Subject: Response to NRC Request for Additional Information Letter Nos. 90 and 142 Related to the ESBWR Design Certification – Safety Analyses – RAI Numbers 15.4-28, 15.4-35 through 15.4-39

**Response to Portion of NRC Request for
Additional Information Letter Nos. 90 and 142
Related to ESBWR Design Certification Application**

RAI Numbers 15.4-28, 15.4-35 through 15.4-39

Figure 1. Pressure and Water mass in the RPV Lower Head in accident scenario AS-2, no MSIV leak. This figure illustrates dry out of the Lower Head caused by high driving pressure across the BDL break.

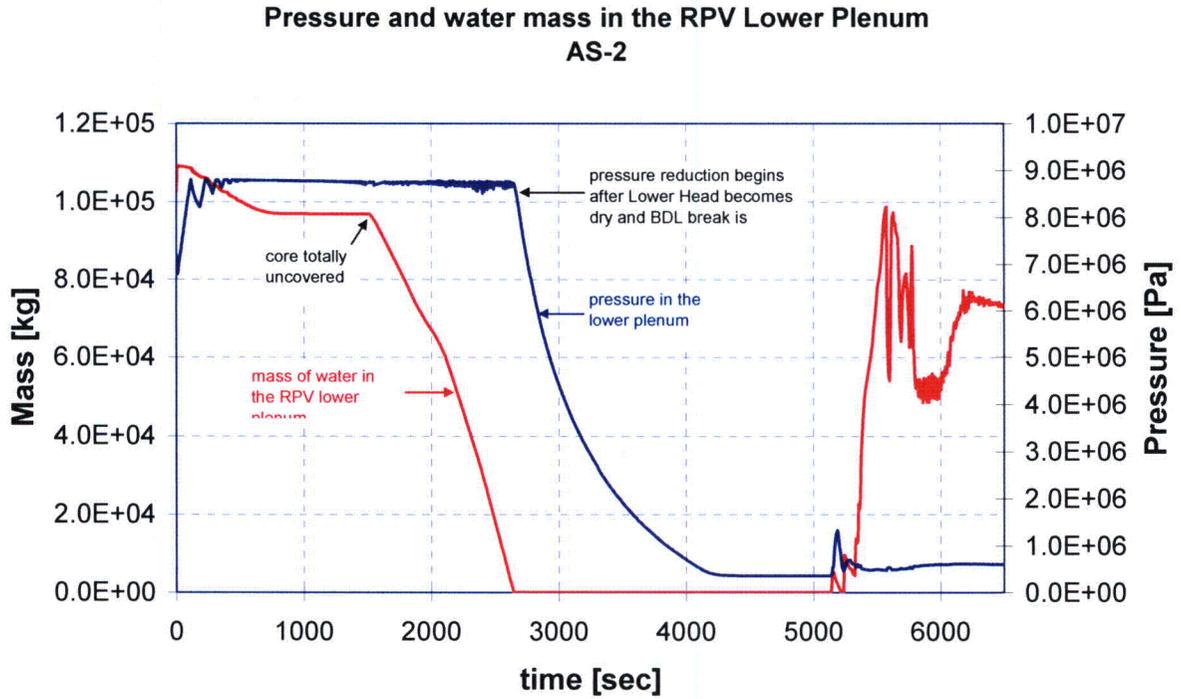
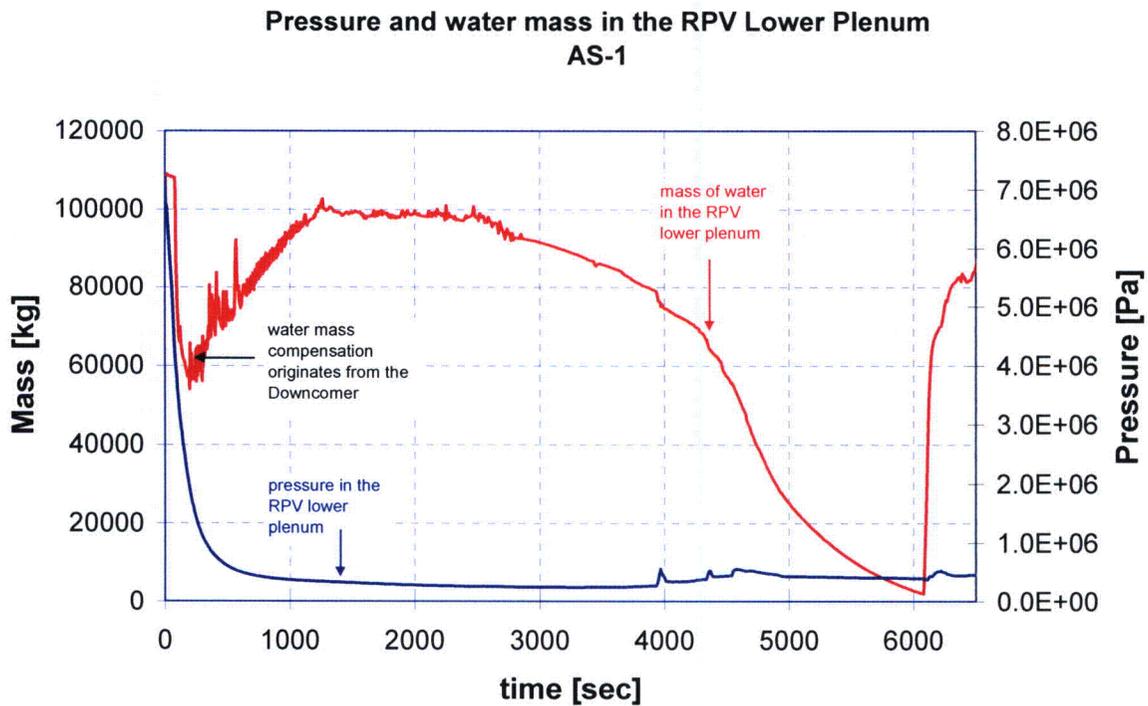
Research Report VTT-R-06771-07 (Part 3), Figures 7 and 14, show the calculated pH in scenarios AS-1 and AS-2 for the different CsOH formation rates, respectively. For AS-2, during the early stages of the accident, there seems to be a rapid increase in pH followed by a decrease, then a small increase followed by a sudden decrease (not shown). Finally, the pH seems to level off between 8 and 8.5. Please discuss the pH behavior in the RPV during the early stages (between 1000 and 10,000 seconds) of scenario AS-2. In addition, given that scenario AS-2 is similar to AS-1, and that the pH behavior is similar for all of the other pools in AS-1 and AS-2, please discuss why the pH behavior in the RPV during AS-2 is different from the pH behavior during AS-1.

The information discussed in this RAI was updated in Revision 2 to VTT-R-06671-07, "Estimation and Modeling of Effective Fission Product Decontamination Factor for ESBWR Containment – Part 3," which was transmitted to the NRC via MFN 07-466, Supplement 1, dated March 31, 2008. The pH behavior described in this RAI also appears in the revised calculations for Revision 2 of the Part 3 report. pH analysis for the RPV in AS-2 is not appropriate for the time period from 2436 seconds to 5145 seconds following the break. Section 8.1 of the revised report explains that MELCOR calculations indicate that the RPV is in "dryout" conditions. It is the lack of water in the lower head of the RPV that causes the erratic behavior predicted in the earlier revision of the "Part 3" report. The MELCOR calculations for AS-1 indicated that the lower head of the RPV does not dry out prior to reflooding due to the lower driving pressure. The other pools' behavior is not significantly different since the driving head of the RPV pressure has little impact on pool parameters.

As seen from the attached Figure 1 of the MELCOR run (of "Part 3" Revision 2), the lower head of the RPV becomes completely dry at approximately 2600 s in the accident scenario AS-2. This is caused by the high-pressure difference across the Bottom Drain Line Break junction. The similar plot from the MELCOR run of AS-1 (Fig. 2) shows that the early depressurization with ADS and DPV valves results in low pressure in the RPV Lower Head and thus lower driving pressure for water discharge from the RPV. In case AS-1, the Lower Head does not become empty during the balance of the simulation. The pH calculated by ChemSheet addresses the pH of the RPV water pool. MELCOR calculations indicate that the RPV is dry between 2436 s to 5145 s; therefore, the pH is calculation is not applicable since no pooling exists. This is the reason for discontinuity of the pH curve in case of AS-2.
